Development Review
Lynnwood Crossing
Draft EIS 11/2/11

Responses to Letter No. 1—Community Transit

PROJECT: LYNNWOOD CENTER ALDERWOOD MIXED USE
 SHEET: C1.01B
 DATE: 04.13.2011
 DRAWN BY: [Name]
 CHECKED BY: [Name]
 APPROVED BY: [Name]
 OFFICE: [Address]
 PHONE: (206) 467-4747
 FAX: (206) 467-4748
 WWW.BCRANDAMERICA.COM

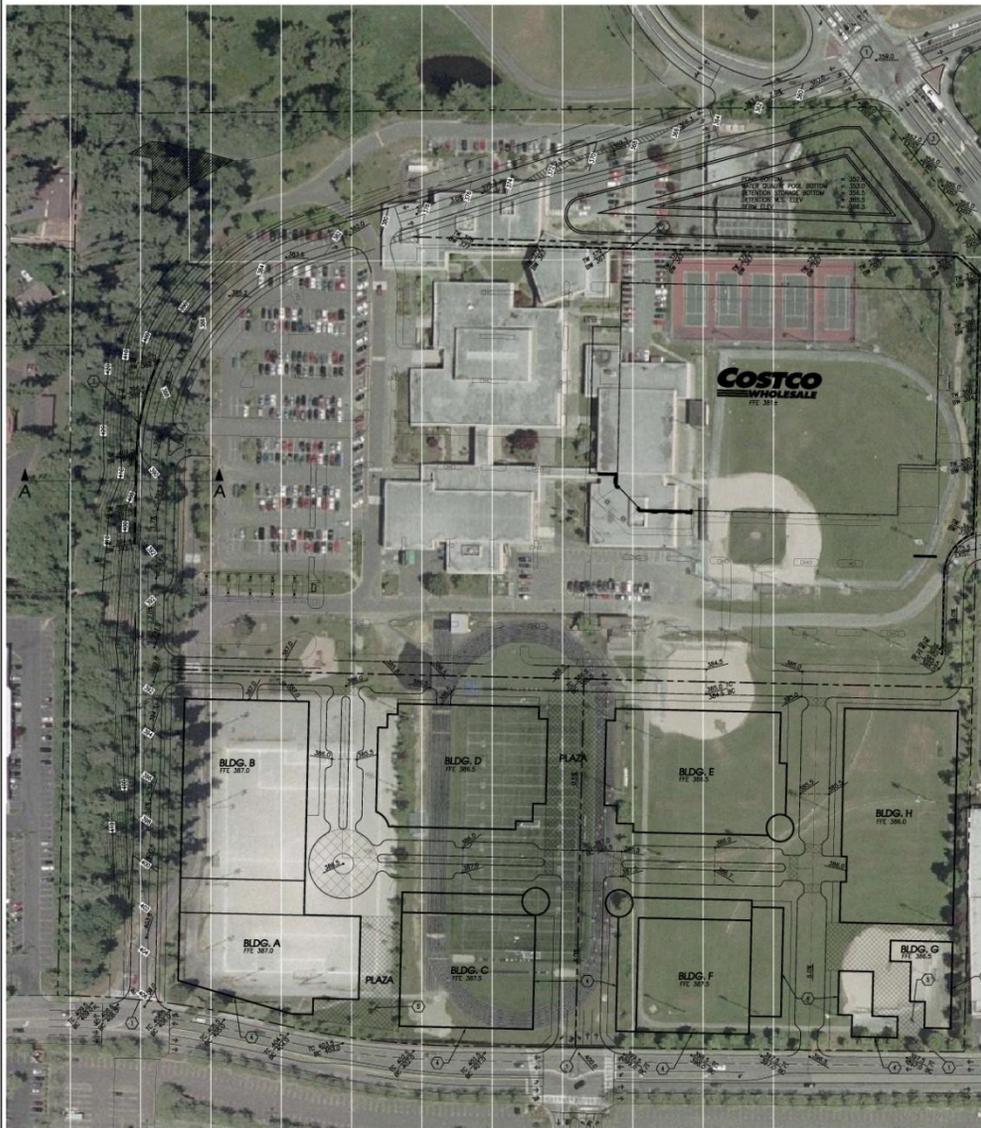
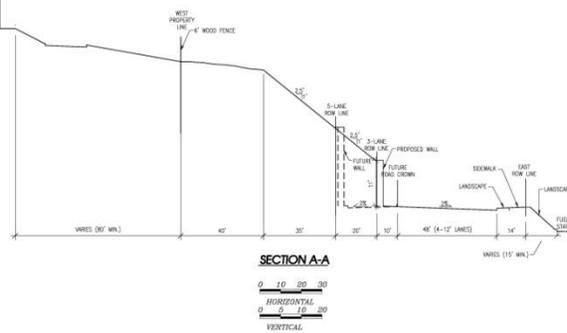
- 1) I asked representatives at the meeting what the height of the retaining wall would be at various points along the new bypass road...not one person there could answer me. It is a little hard to comment on the Draft EIS when you can't get any answers. 1

Comment 1: The wall height and length have been significantly reduced since the EIS was issued and the meeting you referenced occurred. The revised wall configuration, including the length and height, is shown on BCRA plan sheets C1.01A and C1.01B on the following pages. At the tallest point, the wall will be 10 to 13-feet in height. Additionally, a to-scale cross-section showing the location of the apartment buildings to the west, the wall location, and the fueling station has been provided.

Comment 6: BCRA plan sheet C1.01B has been provided that shows an aerial of the site overlaid with the proposed improvements including the proposed grading to the west (see response to Comment 1, Letter No. 7).
